COMMITTEE OF THE WHOLE (PUBLIC HEARING) – JUNE 4, 2019
COMMUNICATIONS

Subject: 919819 Ontario Ltd. 1891445 Ontario Ltd. 5217 and 5225 Hwy 7, 26, 32 Hawman File # op.18.008 and z.18.013

Committee of Whole (Public Hearing) June 4, 2019
Official Plan Amendment File OP.18.008
Zoning By-Law Amendment File Z.18.013
Applicant: 919819 Ontario Ltd. /1891445 Ontario Ltd. Inc.
Ward 2 – Vicinity of Kipling Avenue and Regional Road 7

Proposed road connecting Hwy 7 to Hawman Ave.

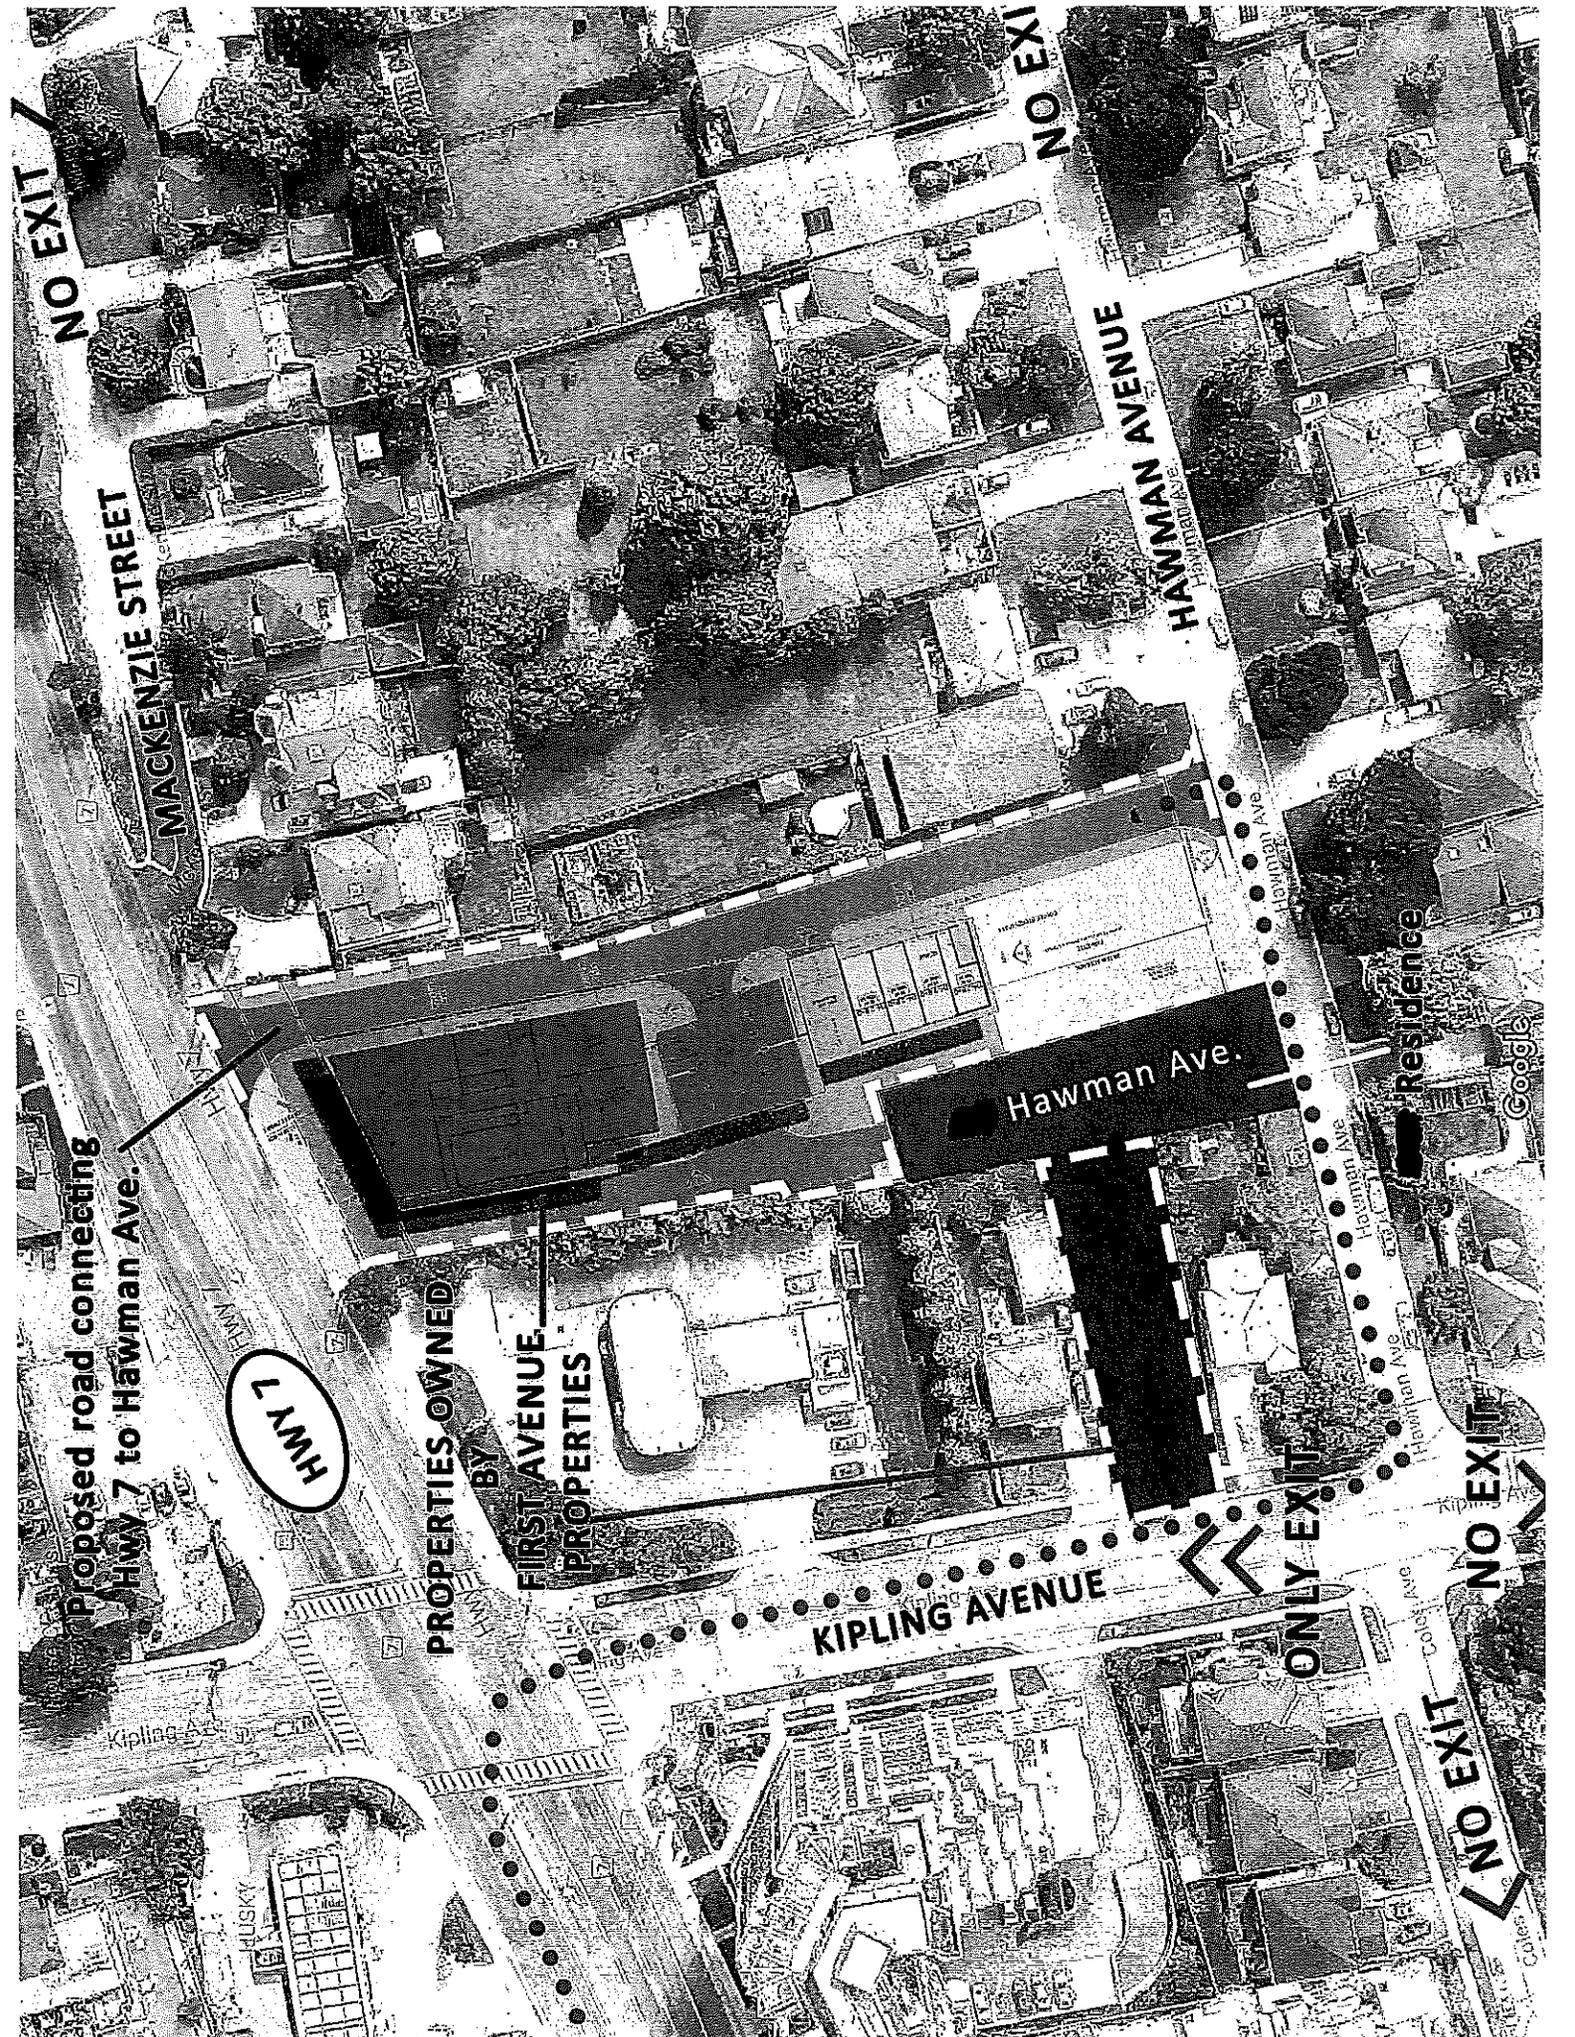
Another big concern is the proposed road/access point that this development wants to create that will stretch from Hwy 7, southbound to Hawman Ave. Currently Hawman Ave is a residential street with no exit, utilized by the local residents only. The only purpose this access road will serve is to allow traffic to flow in/out of the proposed site to travel west on Hawman Ave, then North on Kipling (no southbound exit on Kipling) and then West on Hwy 7. My main concern is that my house and driveway is the only house on Hawman Ave between the proposed road access point and Kipling Ave. I will quite literally be boxed in every morning and evening during rush hour when vehicles will be travelling on Hawman Ave. Not to mention the impact that this additional traffic will have on the residents of Hawman Ave. There is no other exit on Hawman Ave and this proposal concerns me, especially considering that my house in particular is the only one uniquely affected by vehicles that will be lined up in front of my driveway trying to make a right hand turn on to Kipling. Please see the attached jpg file titled "Traffic Concern - [REDACTED] Hawman Ave" that I have prepared which illustrates this concern. Also how will this increase of traffic from this proposed road affect school buses? Currently busses come

DRAWING TITLE
P2 & P1 Parking Level

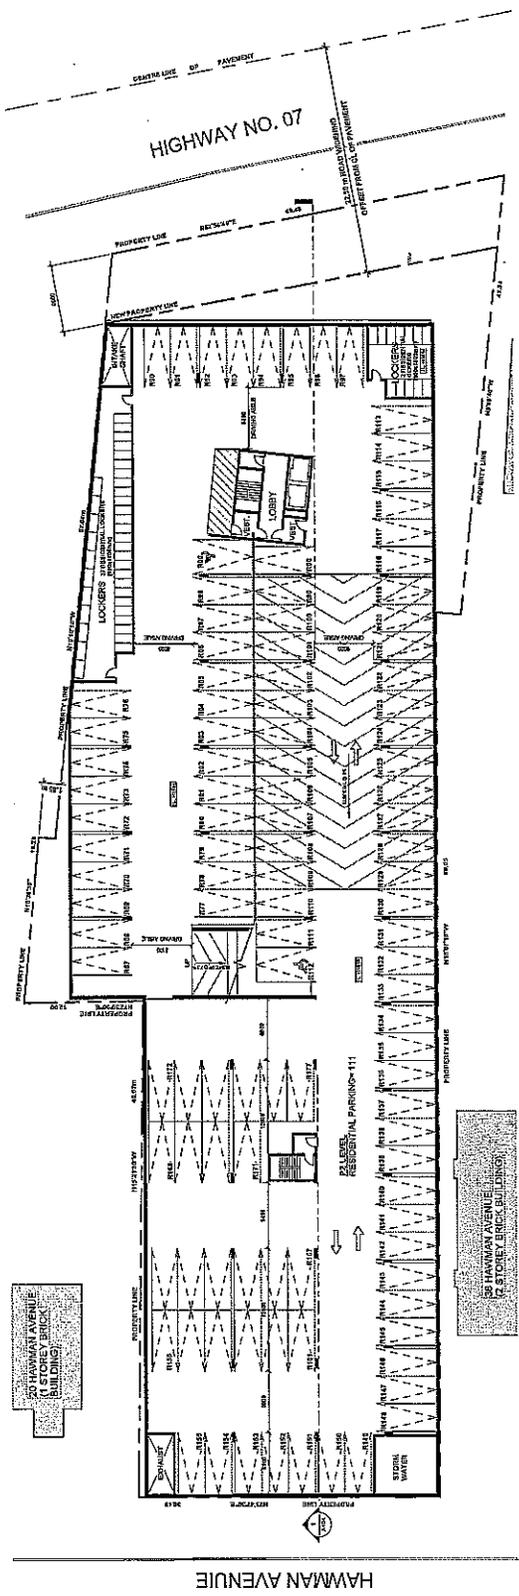
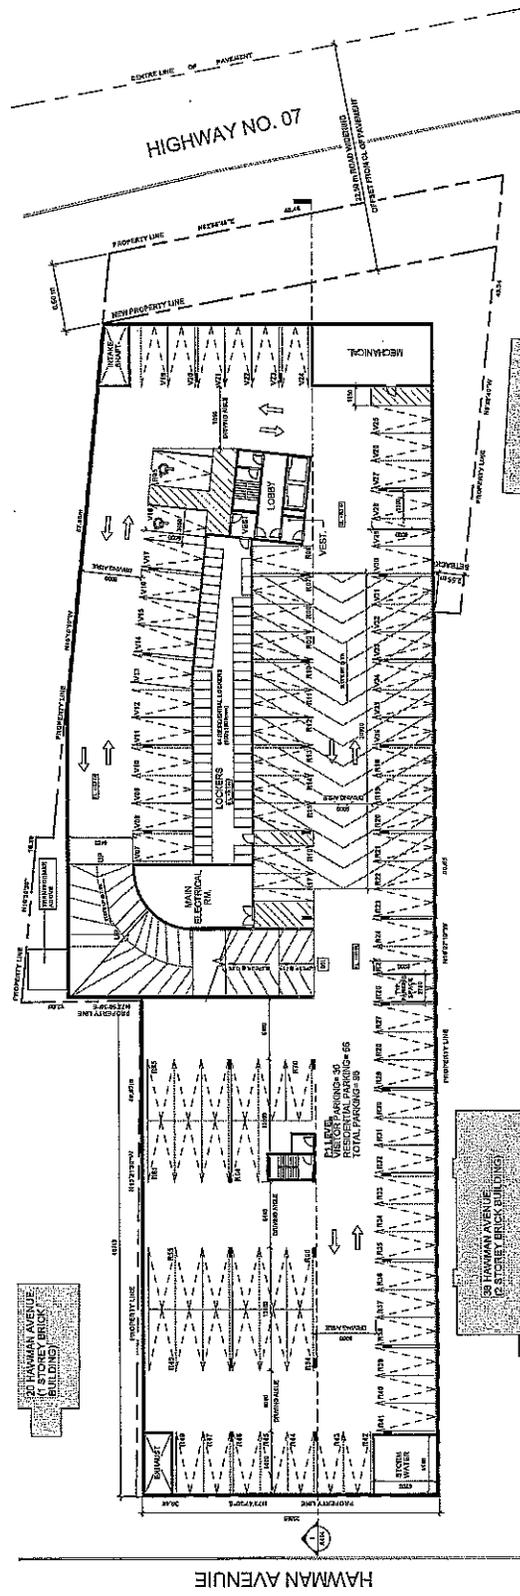
In the official drawings of the proposal, there indicates the desire to have underground parking all along the entirety of the east side of my property. (Please reference PDF SUB1_April-9-2018_A201_Parking Levels_8.5x14_5225 Highway 7 submitted in proposal) During excavation for this work, what precautions will take place to ensure my 18 month old son does not walk into a giant pit in the ground? Will there be a fence put up? Also will this cause damage to the structural integrity of my land that my house is sitting on? What are the actions that will take place to ensure my house does not sink into the ground?
